INDESIT company

Model type:
LV460IX

Commercial code:
F030372

n1045085: Introduction of new litre counter turbine integrated on air-break.

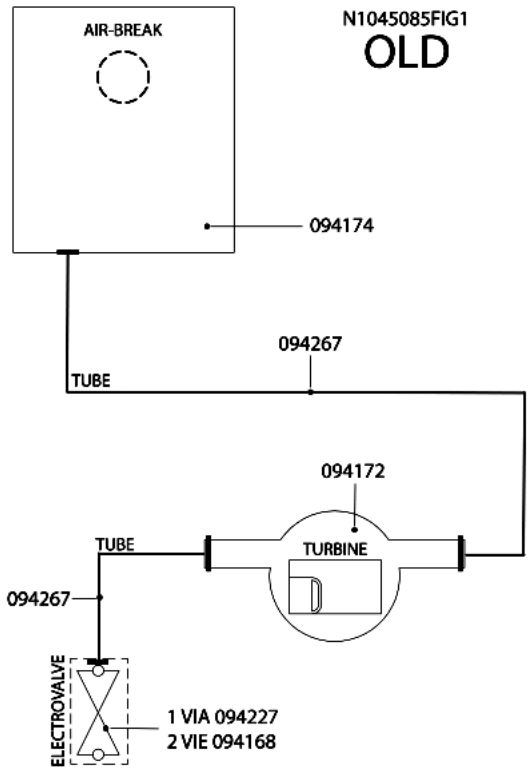
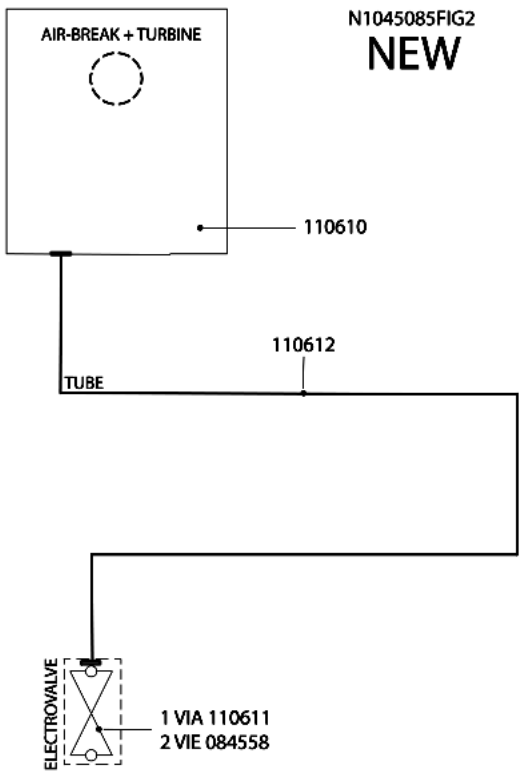
All dishwashers affected by this note have been equipped with a new litre counter turbine on the air-break.
Picture N1045085FIG1 illustrates the premodification structure, picture N1045085FIG2 the new structure.

AIR-BREAK:
new 110610;
premodification 094174;
the new item features a new integrated litre counter turbine and its water supply hose has a smaller diameter.

LITRE COUNTER TURBINE code 094172 has been eliminated.

SOLENOID VALVES:
new:
1-WAY code 110611;
2-WAY code 084558(Rohs 143737);
premodification:
1-WAY code 094227;
2-WAY code 094168;
the new solenoid valves have a smaller diameter drain hose fitting.

HOSES:
new solenoid valve hose/air-break code 110612;
premodification turbine hose/air-break code 094267;
premodification solenoid valve hose/air-break code 094267;
the new hose has a smaller internal diameter.

WIRING:
the litre counter turbine connecting cable is longer, but since the connector is the same, the new item can be used in place of the premodification one.

LV460IX (comm. code 30372)
Wiring Diagram: premodification 16001770400 new 16001881300
Wiring: premodification 110376 new 112487

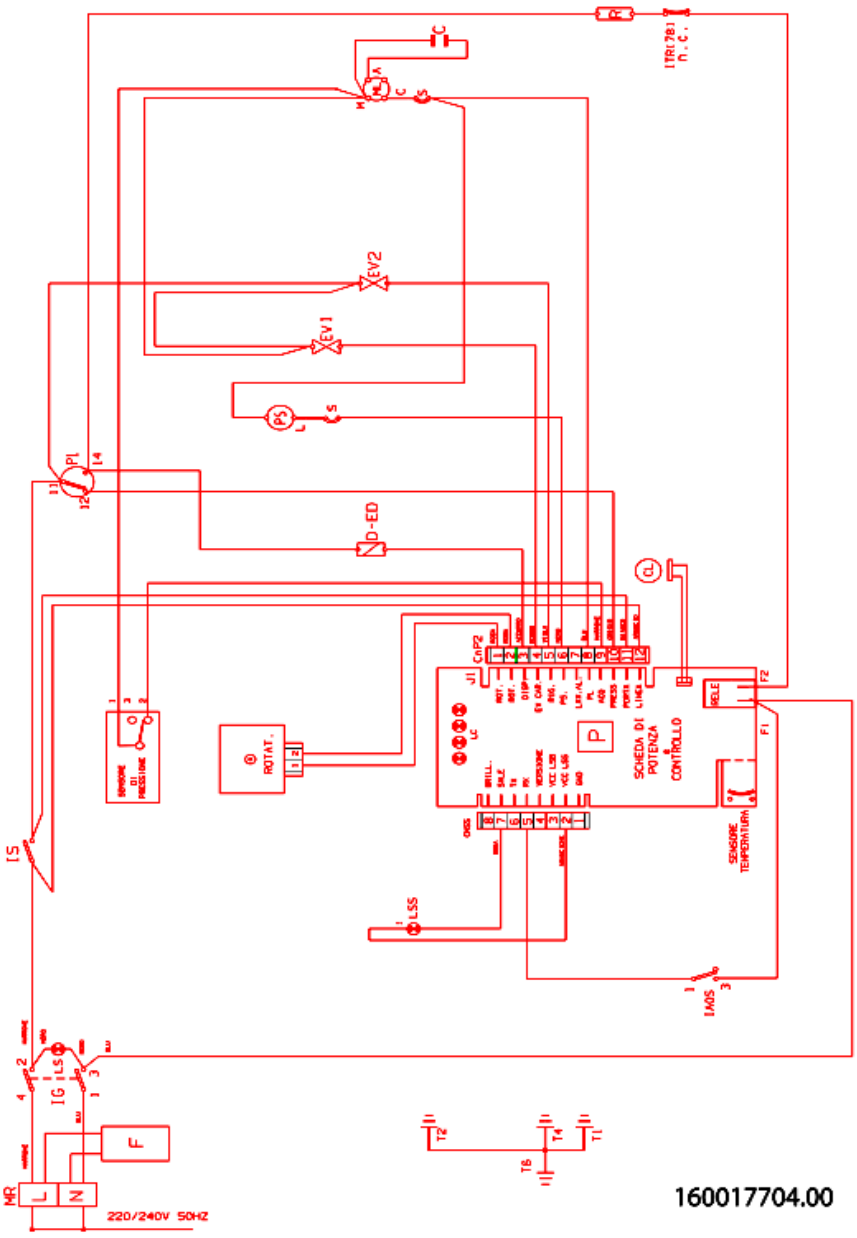
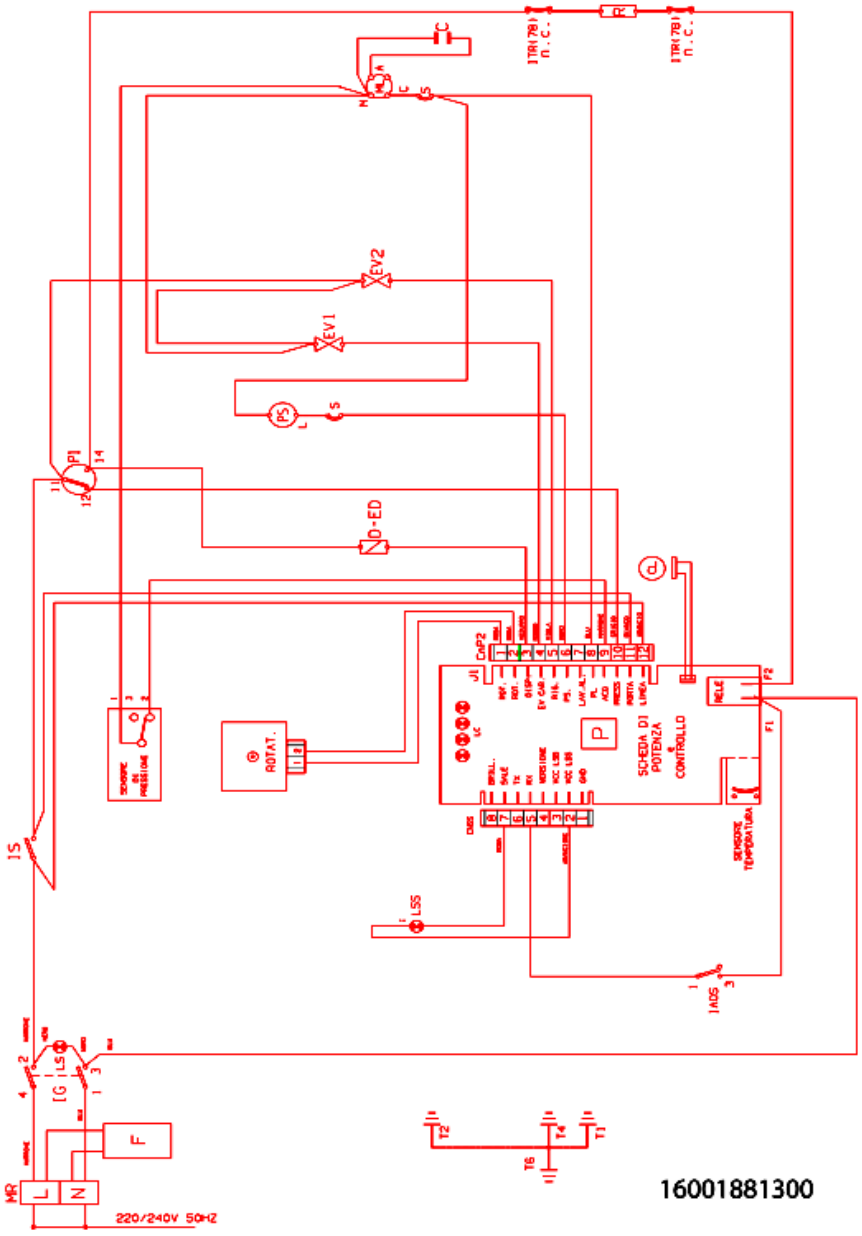
n1045087: Introduction of recessed heating element.

From serial no. 40624.0001, all dishwashers affected by this note have been equipped with a recessed heating element in place of the exposed one located inside the tank.
Given below are the codes of the items concerned:

ELIMINATED ITEMS:
nut + washer code 097871
o-ring seal code 063792
temperature probe code 063791
safety thermostat code 041086
exposed heating element code 066602
heater terminal protection code 074714
upper impeller supply tube code 056001
electrical pump connection tube - upper impeller supply tube code 076233
heater bracket code 054872

INTRODUCED ITEMS:
recessed heating element code 074000
upper impeller supply tube code 094152
heater coupling support code 078394
electrical pump connection tube - heating element code 057710
